This page lists the know errors on the gm5x5x5 PCBs. There are no known issues with the bulk order run (white pcbs), the following information is valid **only** for the prototype run (green pcbs).

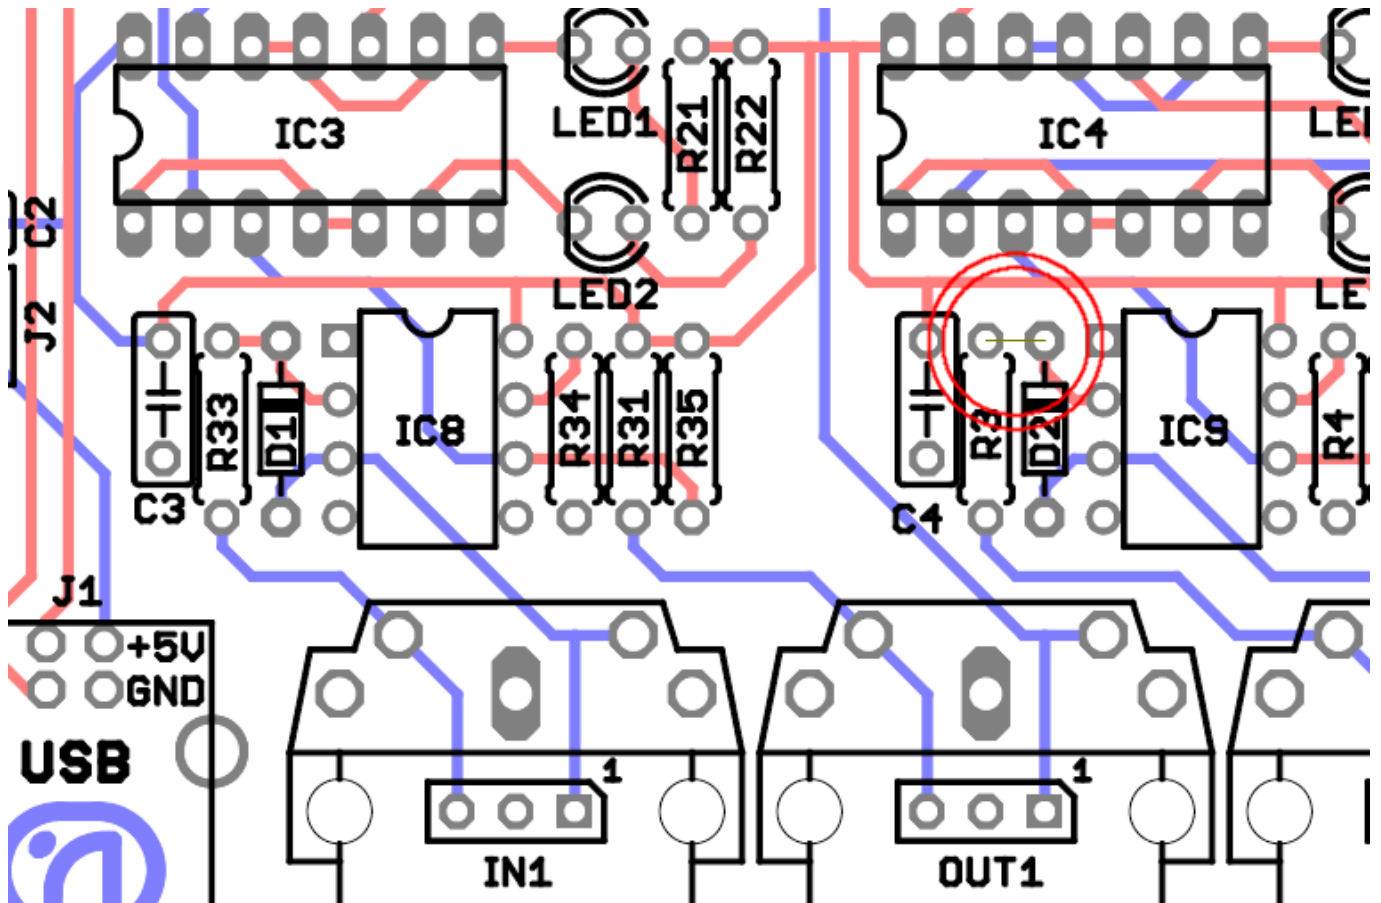
Problem: The silkscreen has the EEPROM the wrong way around - Pin 1 should be facing IC5.

Solution: Stick the EEPROM in the other way around, with the “notch” facing IC5.
